**Streamlined Remediation System Evaluation**  
**Wash King Laundry Superfund Site**  
**Pleasant Plains Township, Michigan**

## **WASH KING LAUNDRY SITE PLEASANT PLAINS TOWNSHIP, LAKE COUNTY, MICHIGAN**

Report of the Streamlined Remediation System Evaluation  
Conference Call Conducted for the Wash King Laundry Site  
July 26, 2010

Revised Report  
February 18, 2011

PCE ISOCONCENTRATIONS(10/27/09)		
CROSS SECTION N1 - S1		
WASH KING LAUNDRY		
9247 S. M-37		
BALDWIN, MICHIGAN		
06-712-01	FEBRUARY 2010	FIGURE 15 B

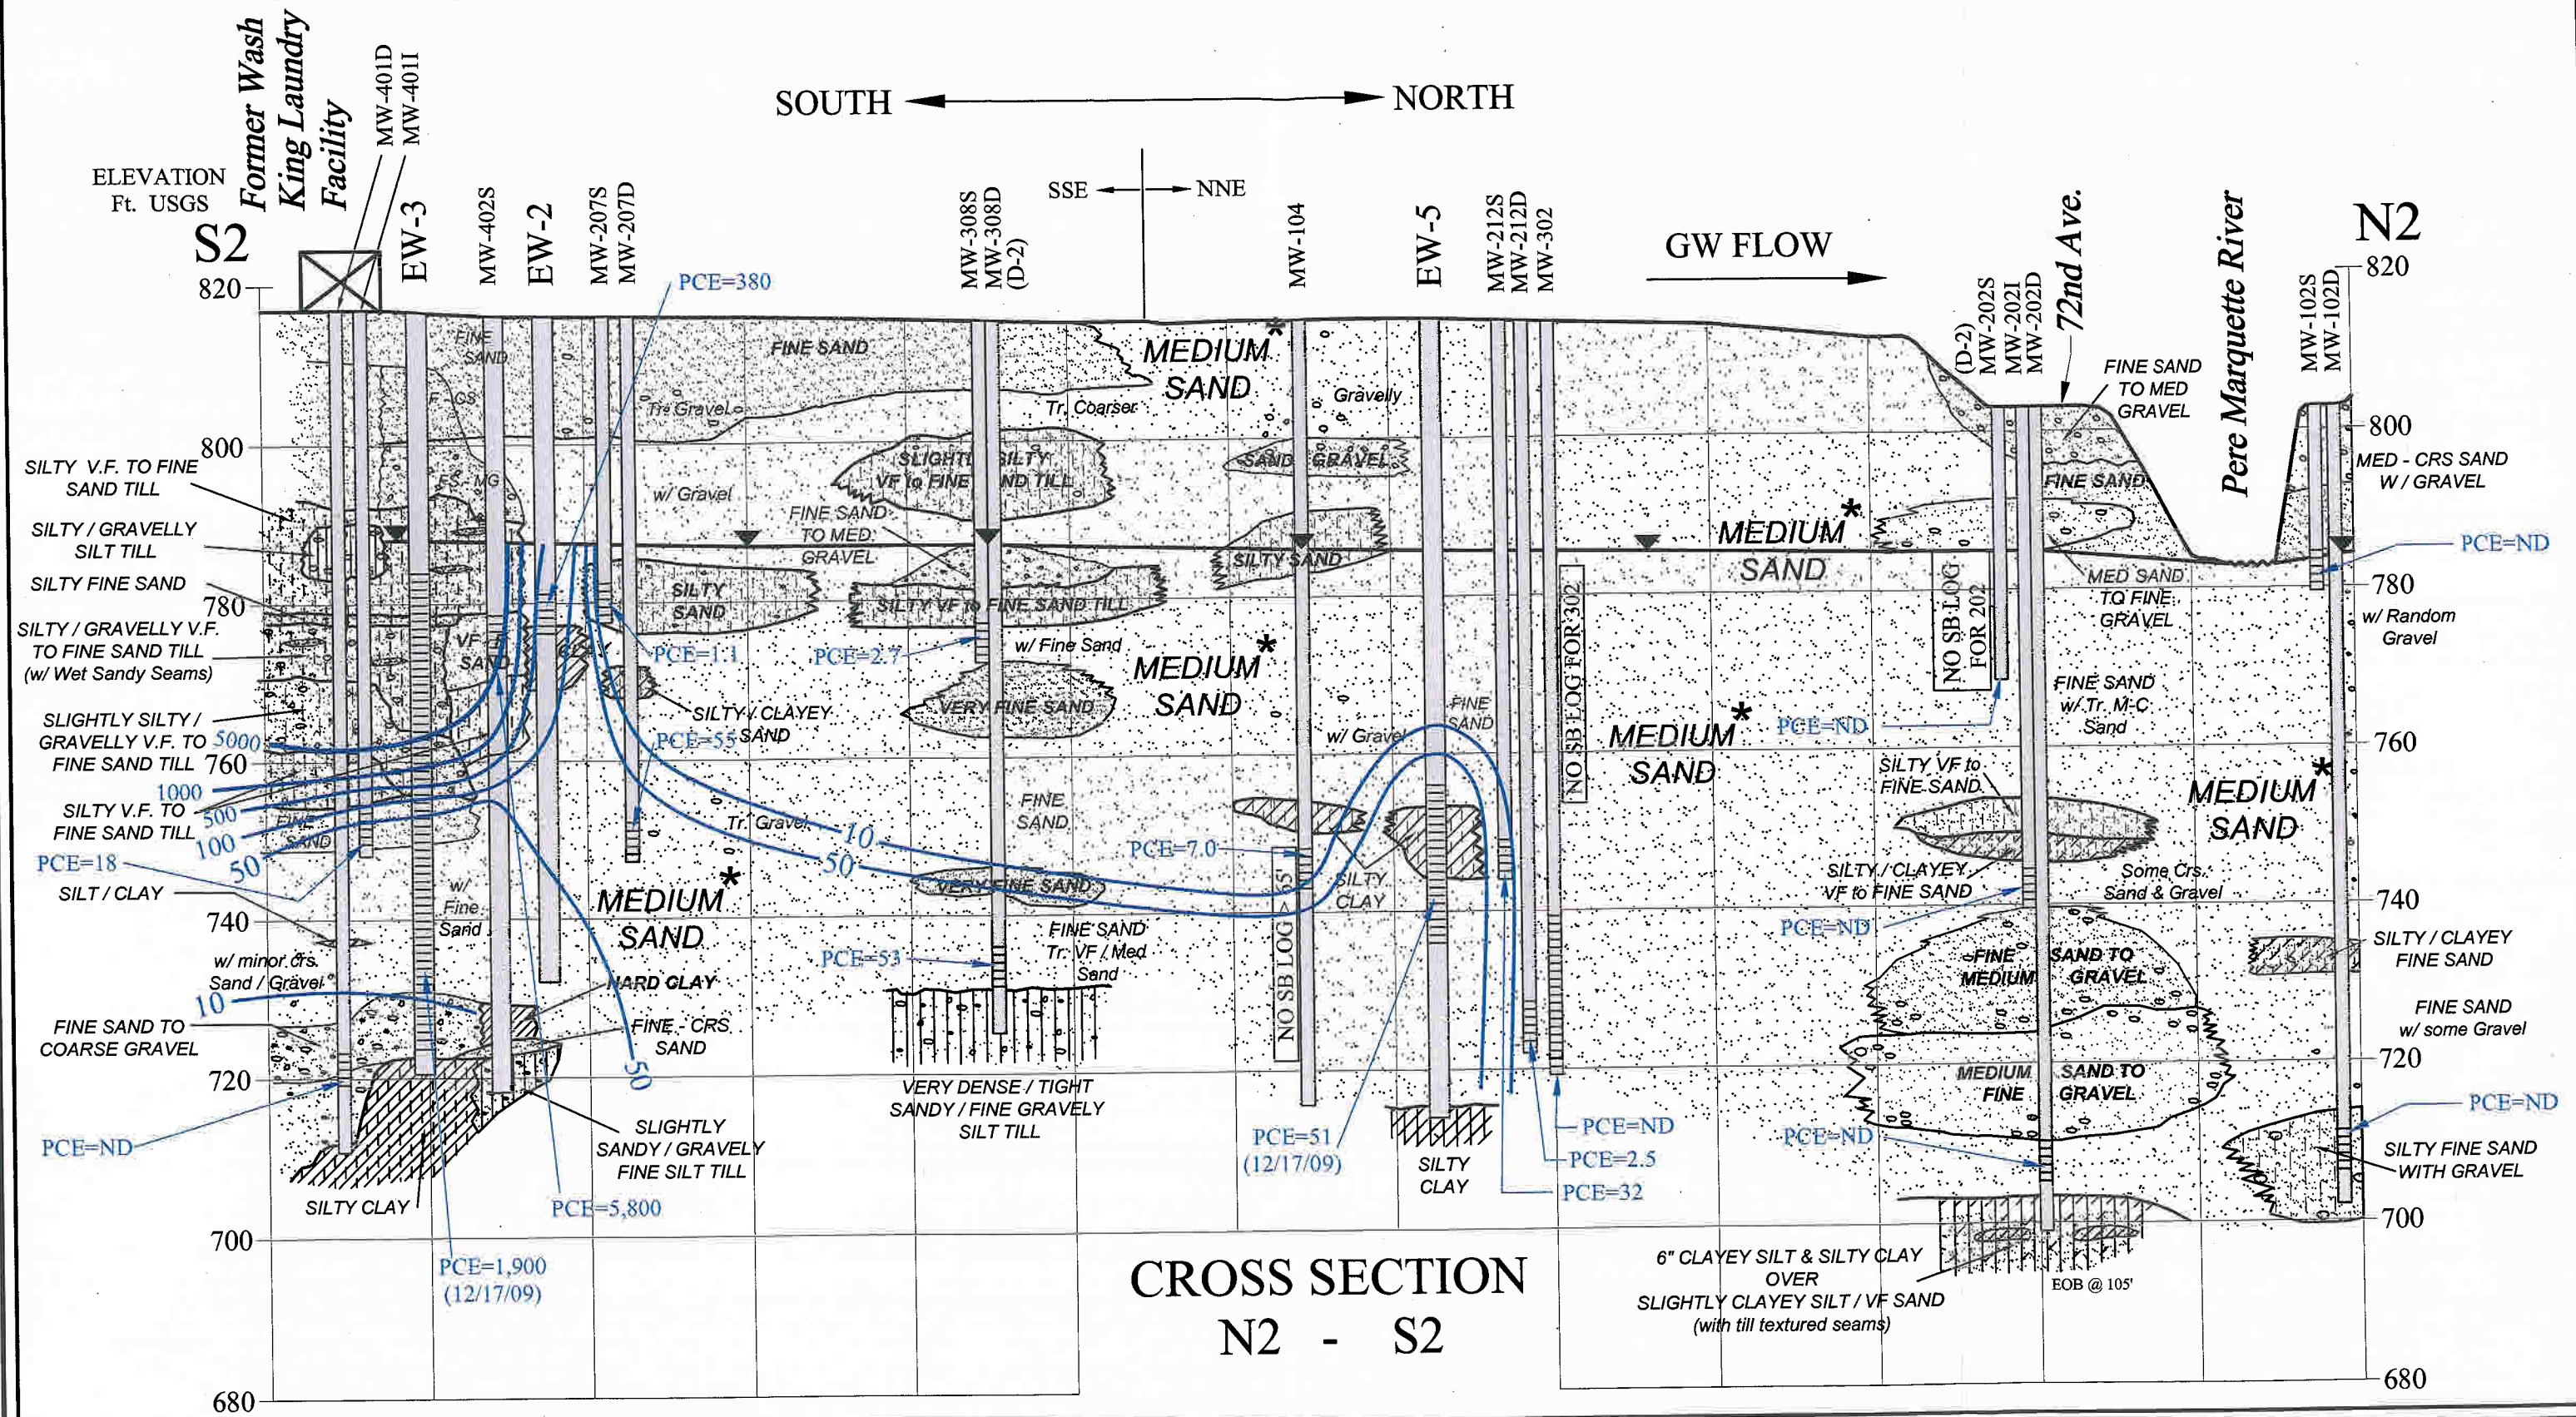
The vertical distribution of contamination is also presented in the north-south cross-sections presented in Figures 15B, 16B, and 17B.

WASH KING LAUNDRY 9247 S. M-37 BALDWIN, MICHIGAN
06-712-01
MAY 2008
FIGURE 11

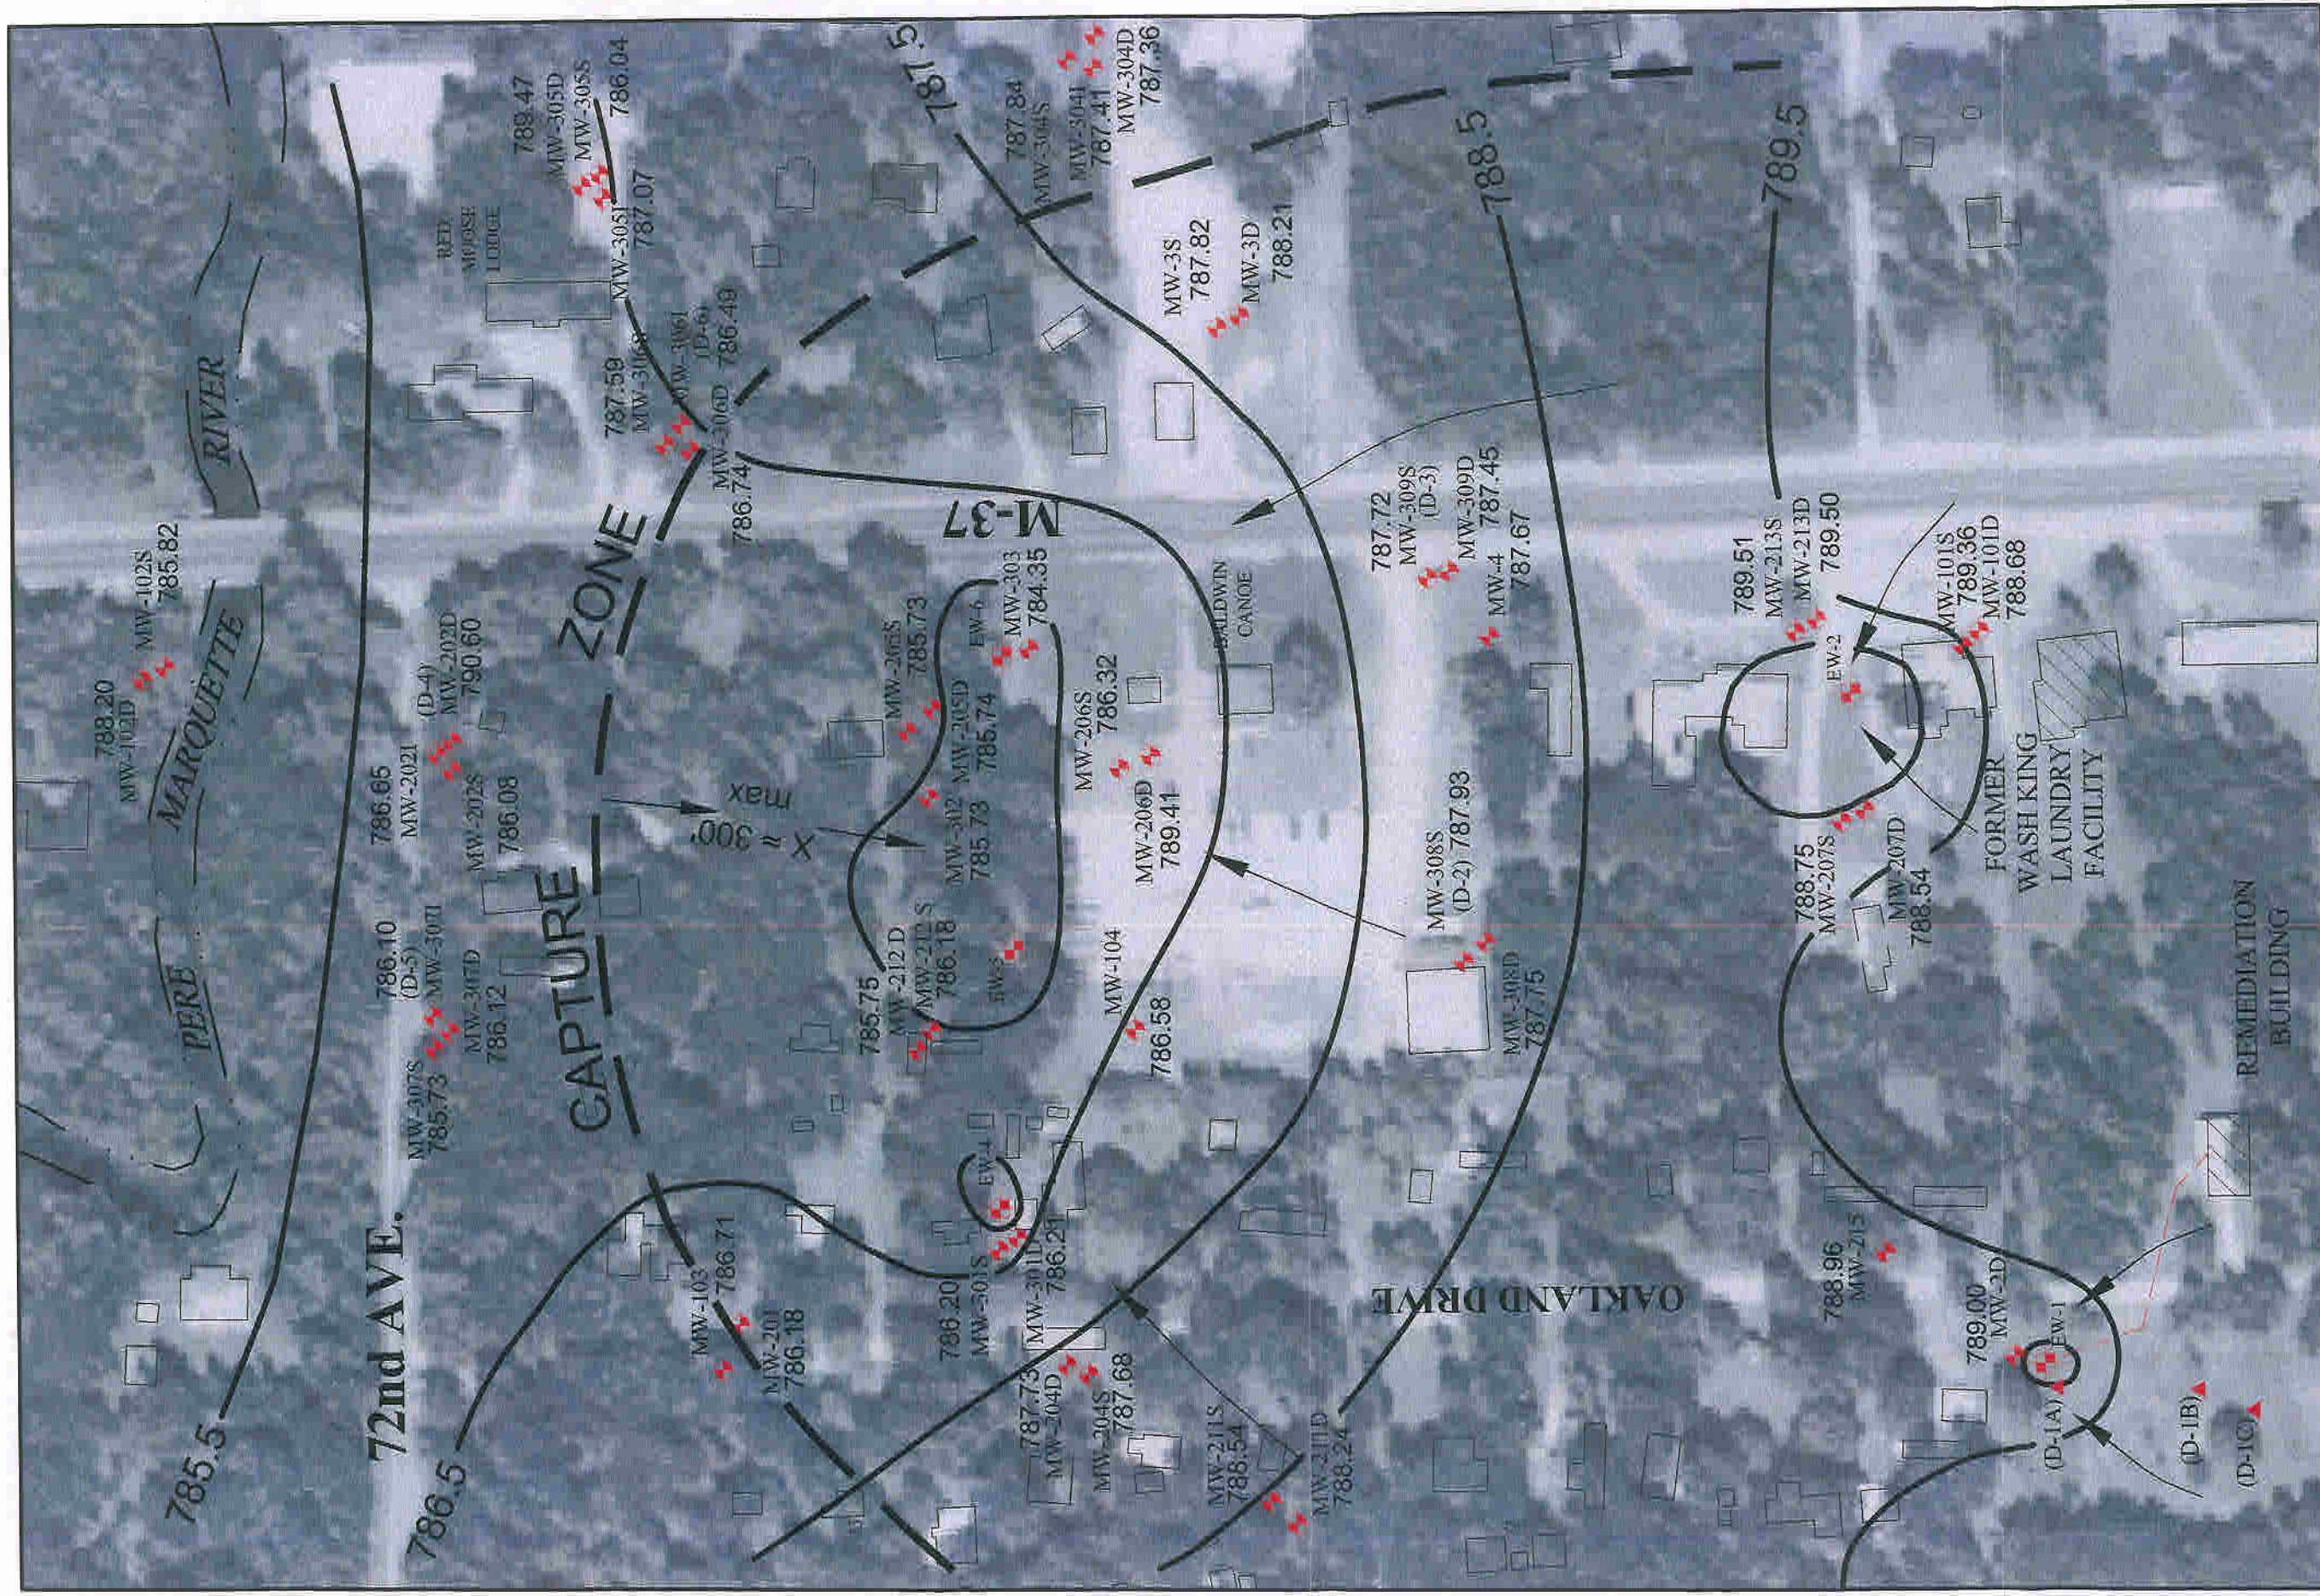
Groundwater flow under non-pumping and pumping conditions in 2008 (prior to the installation of EW-7) are presented in Figures 11 and 13 (see Attachment A). Figure 11 illustrates that groundwater flows to the north, north-east toward the river, and the slight curvature of the contours in the vicinity of EW-6 may result from incomplete aquifer recovery prior to collecting the non-pumping round of water levels. Figure 13 provides the site team's depiction of the horizontal capture zone. The RSE-lite team evaluated the water levels and potentiometric surface map and generally agrees with the interpreted potentiometric surface map and extent of the capture zone in the vicinity of EW-4, EW-5, and EW-6. In general, when evaluating capture in the area of these wells, the intermediate and deep wells should generally be used because that is the interval where most of the contamination is present. There are a few instances where water levels from individual wells do not appear accurate based on water level measurements from surrounding wells or other wells in the well cluster. MW-202D and MW-206D are a few examples. The inconsistencies appear to occur during each water level event, suggesting that a survey error may be the cause.
